DYNAMIC SWEATER INDUSTRIES LIMITED (DHAKA SWEATER) (Extension)

5 February 2024

1. Building Information

Finished Goods Warehouse: is a single storied steel shed.

Observation-1: Lack of information in as-built drawing.

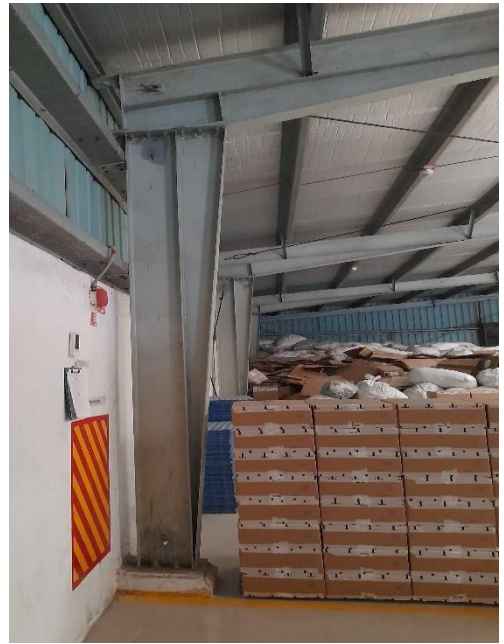
Description: During inspection, only as-built architectural and structural drawings for steel parts were available. The details of the RC columns and sub structures such as pedestal, grade-beam and foundations has not been provided in the drawing.

The vertical cable bracing was not found at site as per provided as-built drawing. The cable bracing was found missing as marked in figure.

Building Engineer is required to survey the whole structure and prepared accurate as-built drawing including the foundation information.

Observation-2: Missing continuous lateral load transfer media.

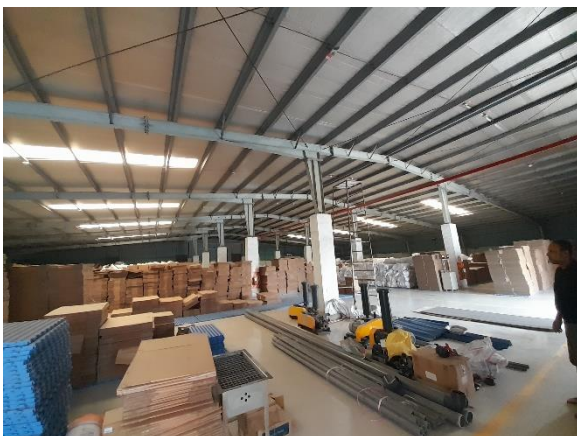
Description: During inspection, Lateral load transfer media (compression strut) along the ridge and eaves were missing. Also, cable bracing at roof and wall seems to be inadequate. The building engineer is required to check the lateral load path and review the stability of the structure accordingly.

Also, the sub-structure information was not available in as-built drawing as well as sub-soil investigation report was not available.

The building engineer is required to prepare a full set of design documents including the adequacy of the RC columns, grade beam and foundation.
